memorandum

T10/07-164r1

To	From	Subject	Date
INCITS T10 Committee	Curtis Ballard, HP Michael Banther, HP	Automation Encryption Control	31 August, 2007

Figure 8 — UML example of SCSI target device and physical device

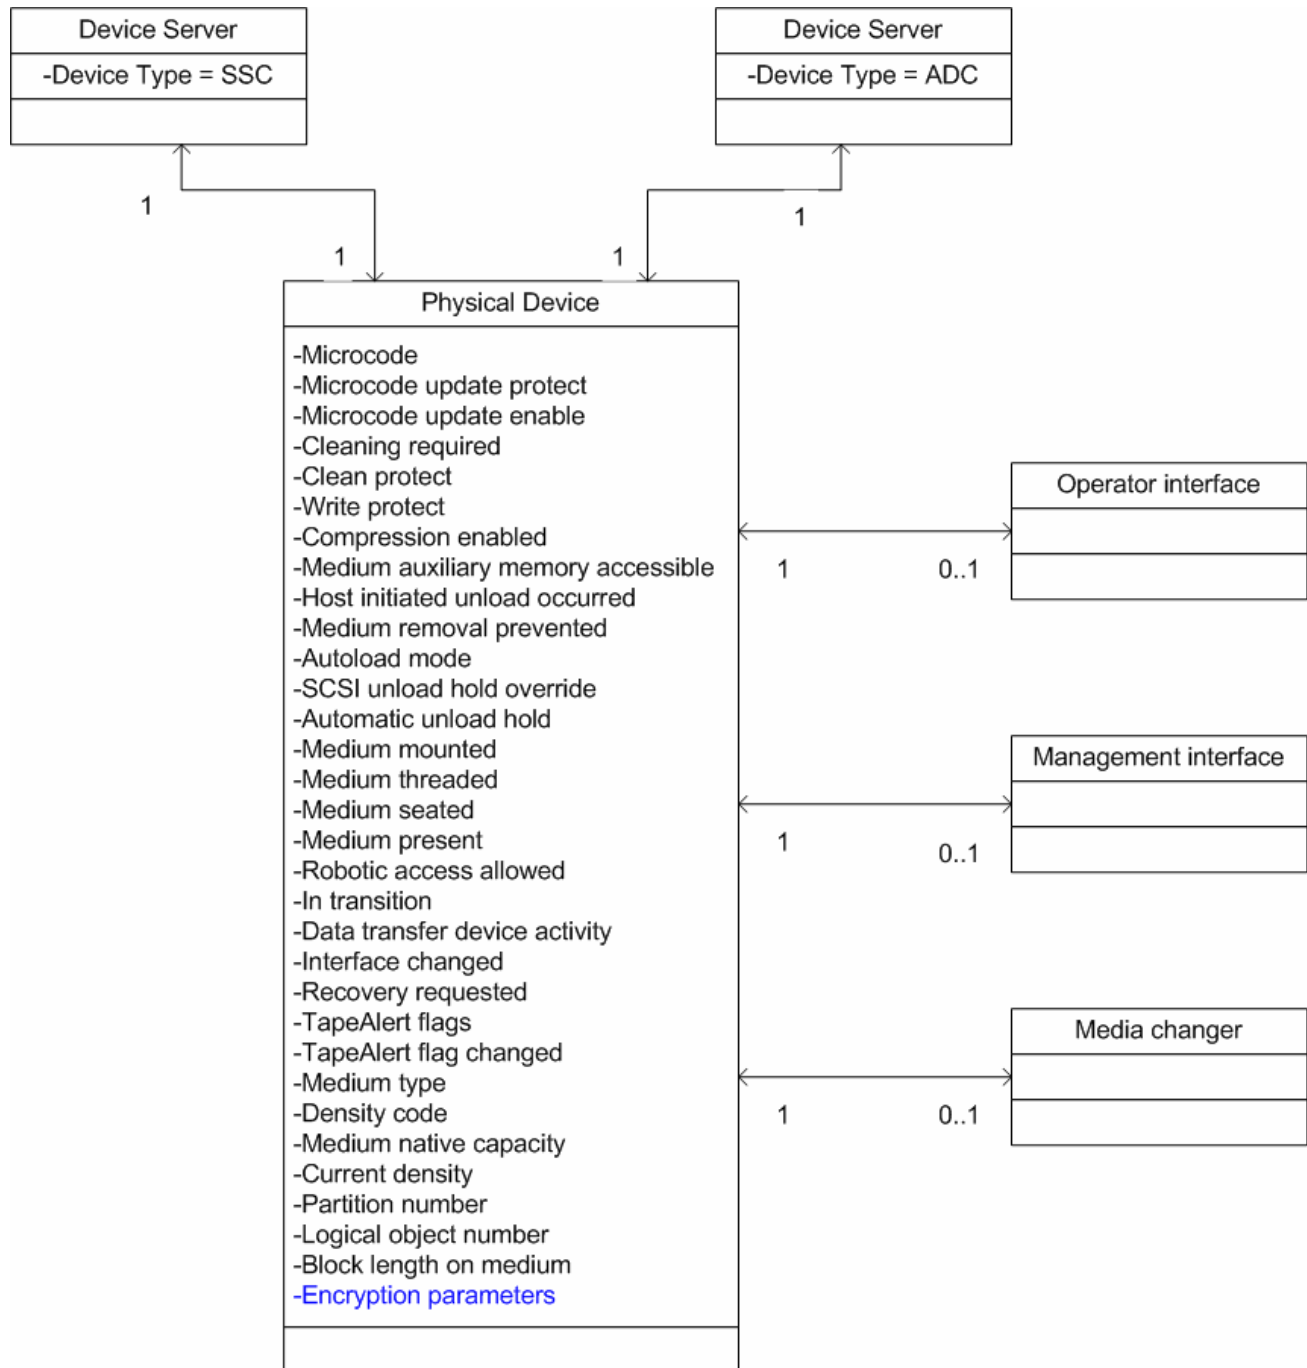
Add encryption parameters to list of items in physical device in figure 8.
